# CITY OF CANNON BEACH

## **WATER RESILIENCY PHASE 1 – SEISMIC IMPROVEMENTS**

### **ADDENDUM TO ITB - 2**

# ENGINEERING PLANS - ADDENDUM 2

E102

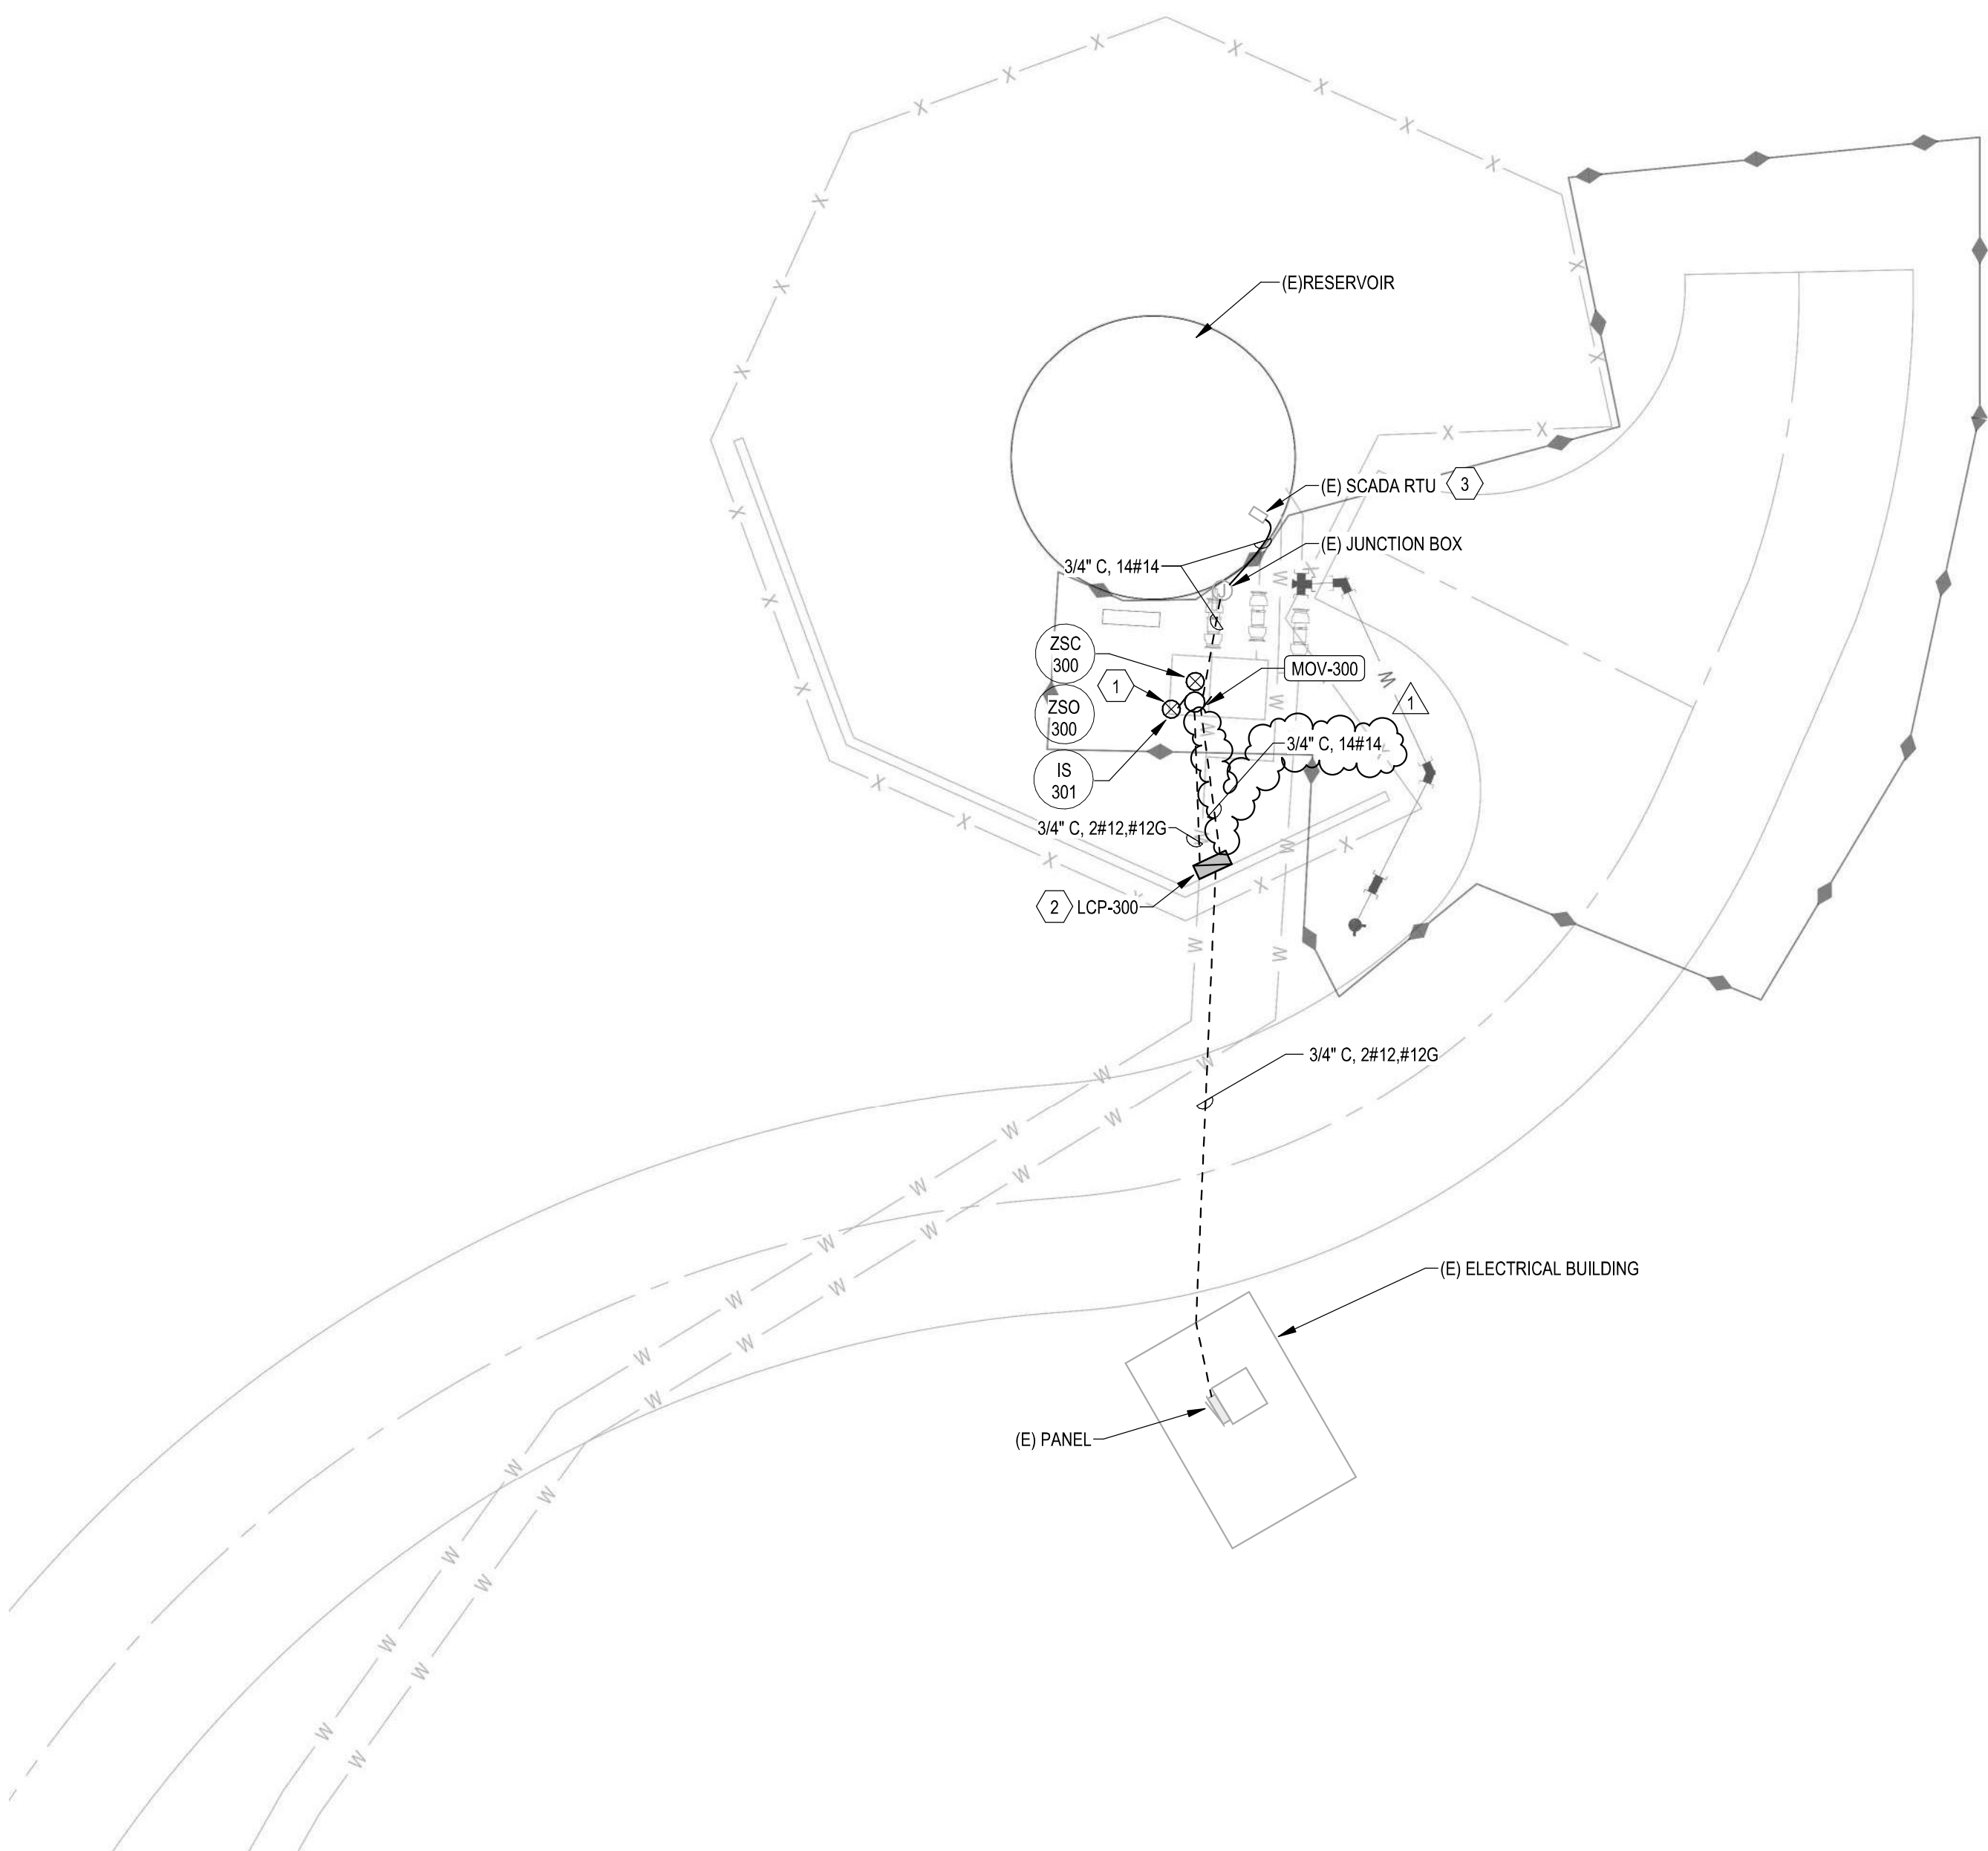
9. Plan Sheet E102
  - a. Added a second conduit and wire line
    - i. ¾” C, 14#14
10. Plan Sheet E601
  - a. Added callout to North Reservoir One-Line Diagram – Electrical & Controls detail.

SWING OUT PANEL

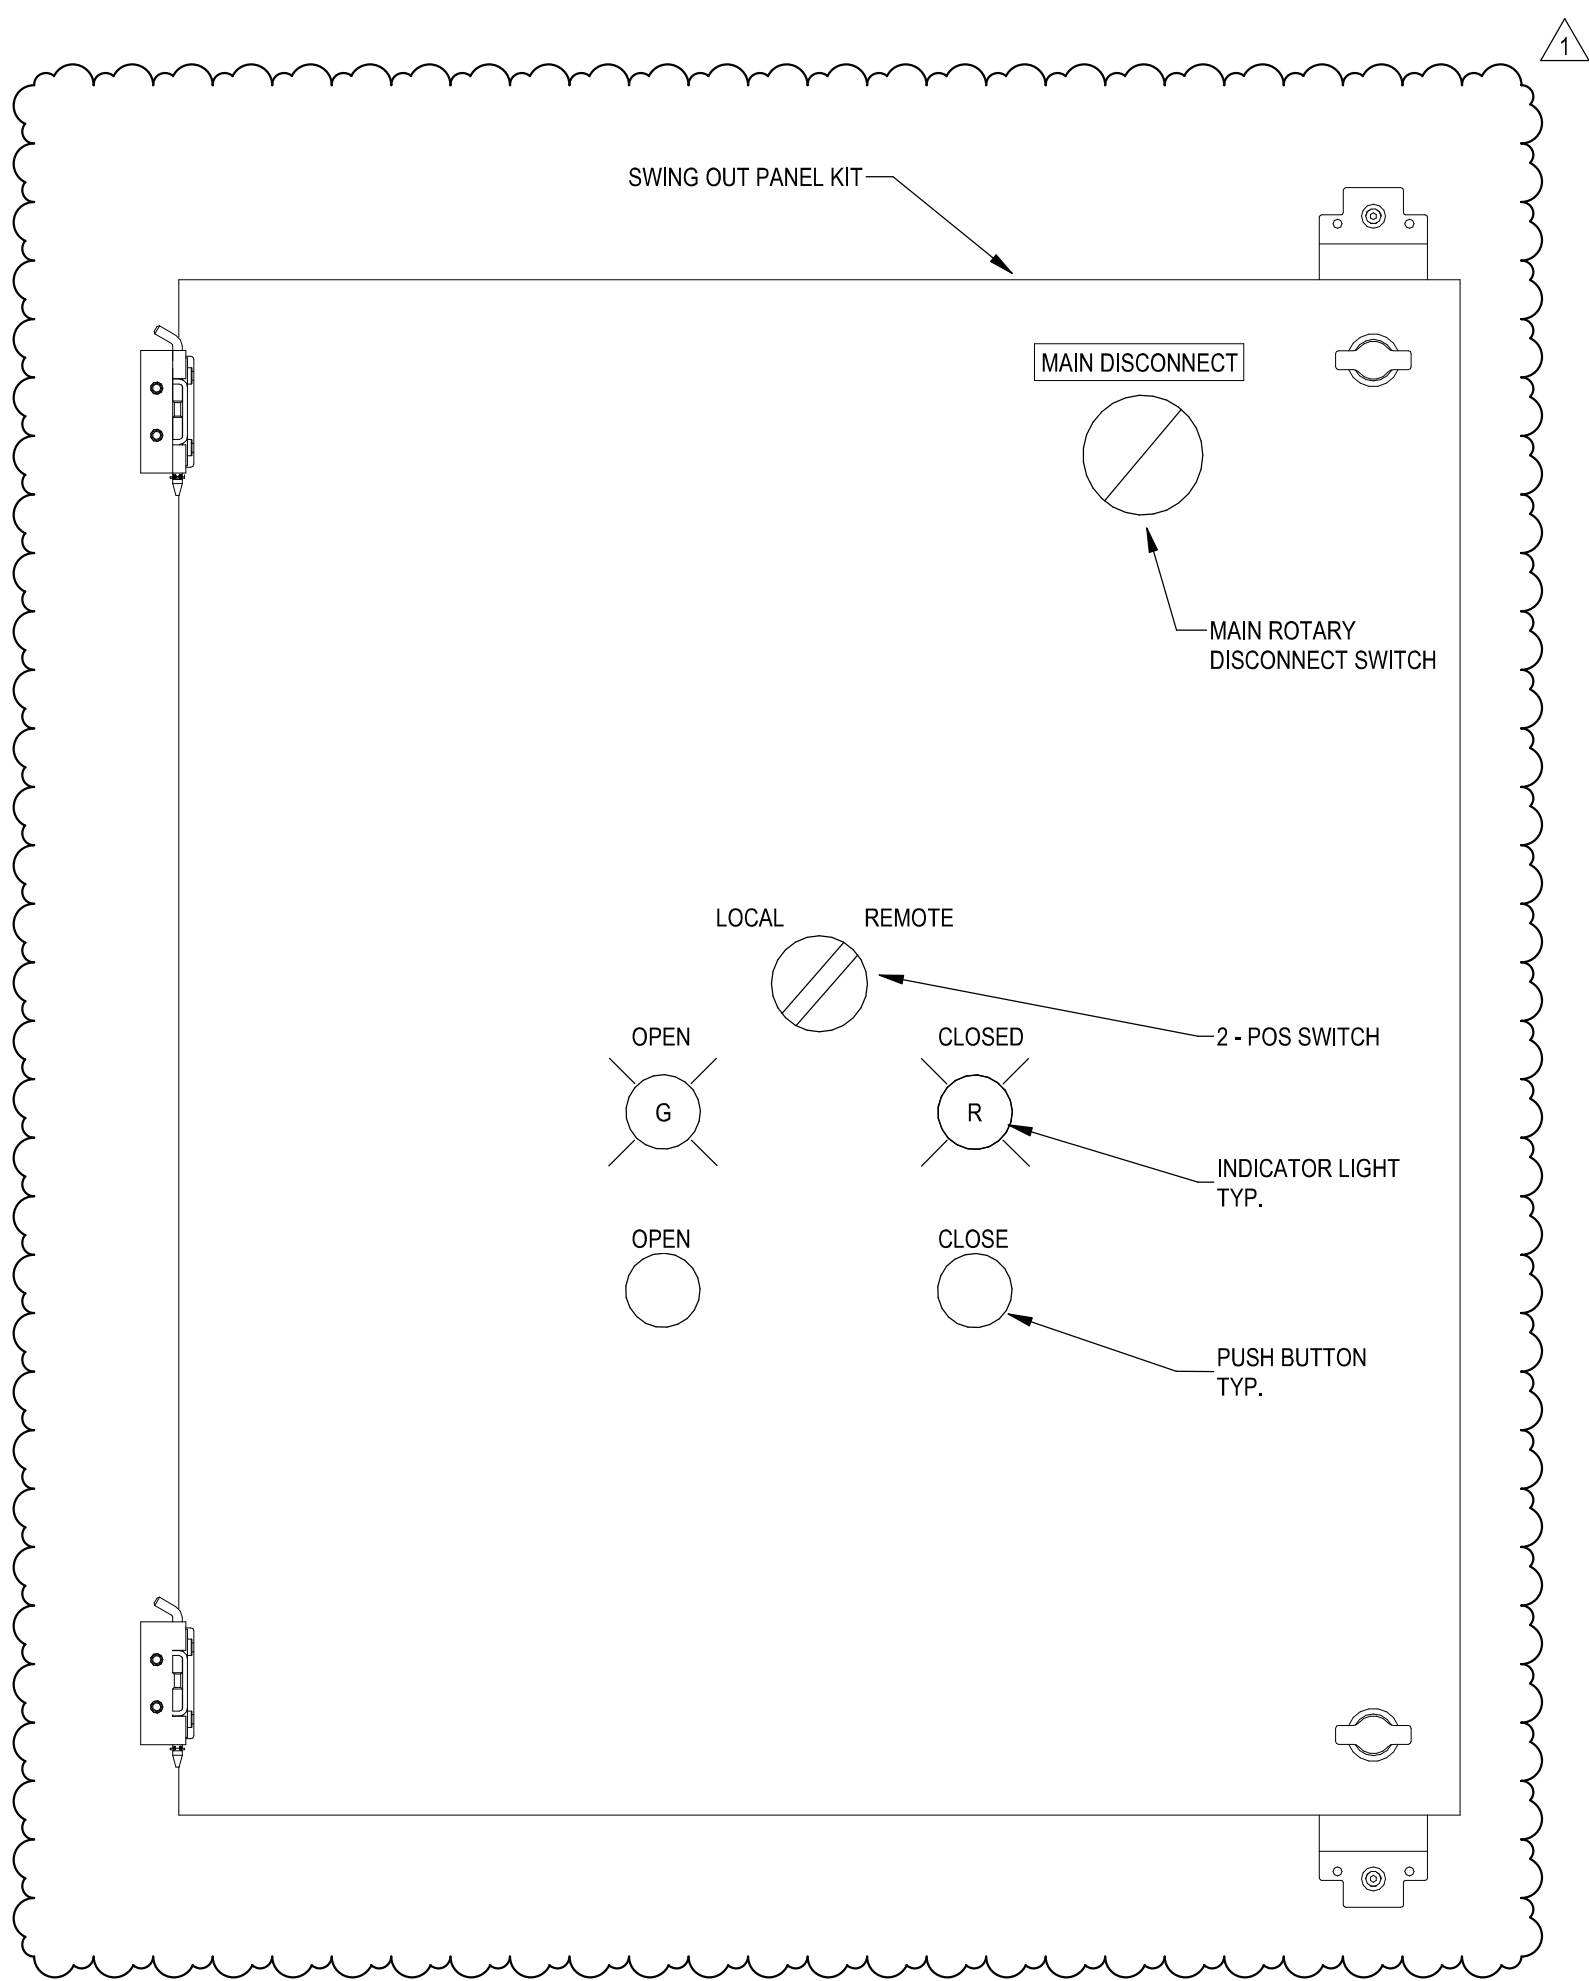
11. Plan Sheet E701
  - a. Updated Swing Out Panel.
